TECHNICAL BULLETIN

100, 200, 400, Mini, 200 Cabriolet, Coupe, 400 Tourer,
(200/400 previous model)

Bull. N°: 0030

SECURITY ECU PROGRAMMING - PARTS CHANGE

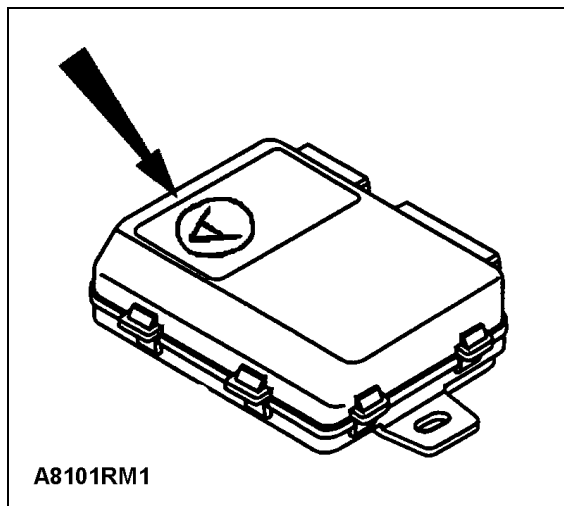
Two new 'non-programmed' ECU's have been introduced allowing many model versions and territories to be programmed from the same ECU.

The new ECU can only be fitted to vehicles having the latest Lucas 5AS security ECU.

- Check model has Lucas 5AS (see 'Affected Range').
- The latest 5AS ECU has two connectors, one grey 26 way and one white 12 way (the white connector is unused on some models).

The replacement ECU will require to be the same radio remote frequency as the original, hence two ECU part numbers (see 'Parts Information').

As a general guide 433 MHz frequency remotes are fitted to UK and European vehicles and 315 MHz to the rest of the world. If the territory frequency is uncertain, confirmation may be established as follows:

The frequency of the original ECU can be identified by a single large letter printed on the ECU casing:

- Letter 'L' 'H' 'R' or 'A' indicates frequency is 433 MHz (replacement ECU has ID 'A').
- Letter 'M' 'K' 'S' 'T' or 'B' indicates frequency is 315 MHz (replacement ECU has ID 'B').
